Specification 50428S  
Issue 1, Page 1  
April, 1966

## INSTRUCTIONS FOR INSTALLING THE 185730 MODIFICATION KIT TO ADD MOTOR FUSE TO MODEL 32/33 SETS

Addendum to Specification 50428S  
Issue 1, Page 1  
Dated April, 1966

ADDENDUM TO SPECIFICATION 50428S COVERING THE  
185730 KIT TO ADD MOTOR FUSE TO MODEL 32/33 SETS

FIGURE 1

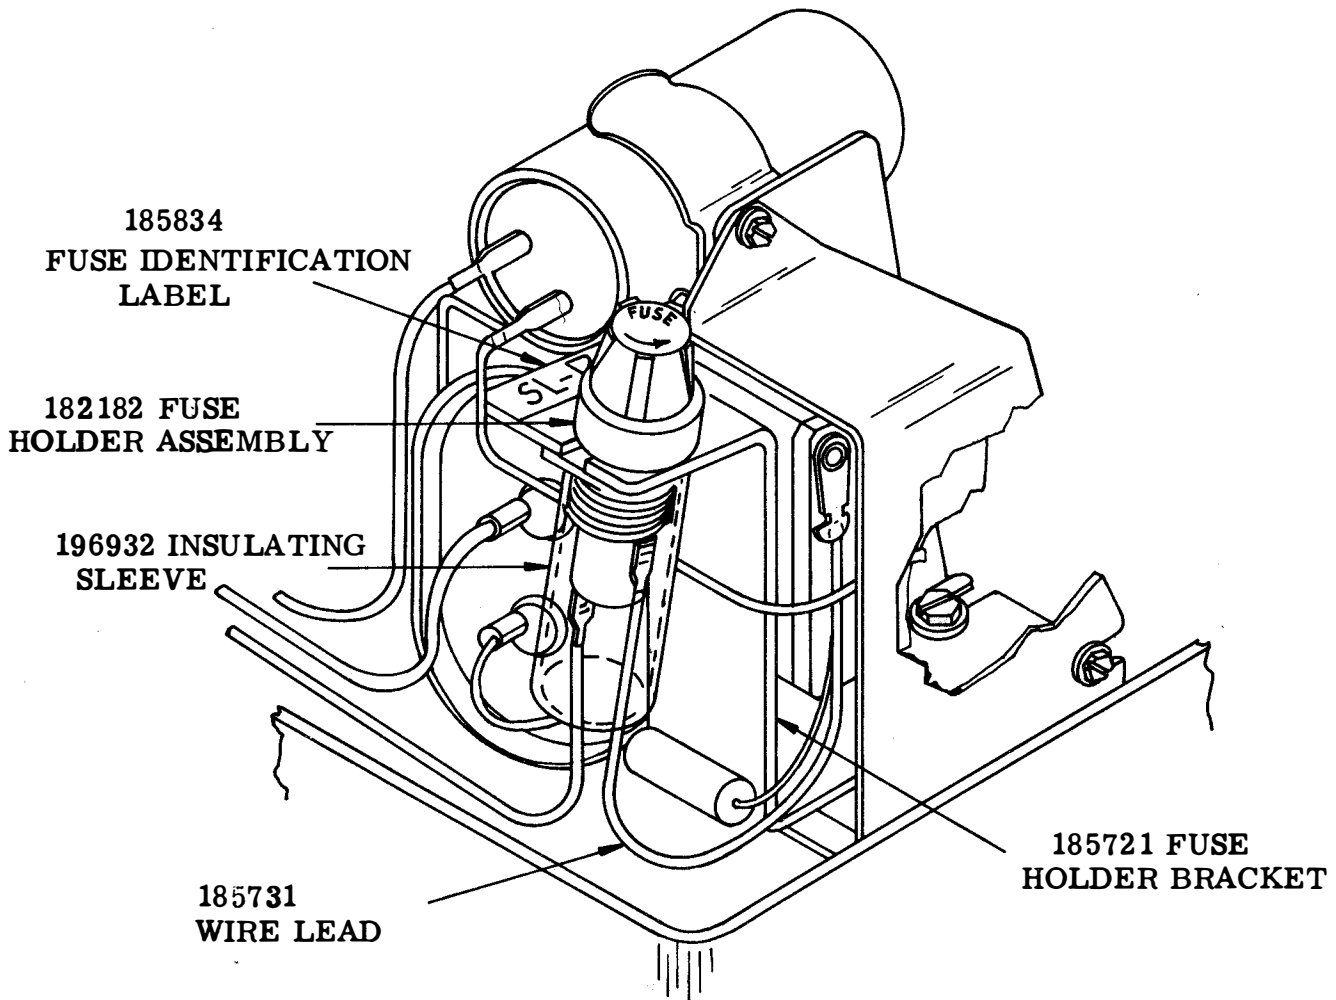
a. On Page 2 add the following to Paragraph 2. k. : Sets that have the motor starting relay on the hot side of the line require no further changes. If the motor starting relay is on the ground side of the AC line exchange the motor leads at the printer terminal block. This change will put the motor starting relay on the hot side of the line. Refer to the wiring diagram of the set involved.

b. On Page 2 add the following to Paragraph 2. g. Straighten the end terminal of the 182182 fuseholder assembly as necessary to install in the proper manner.
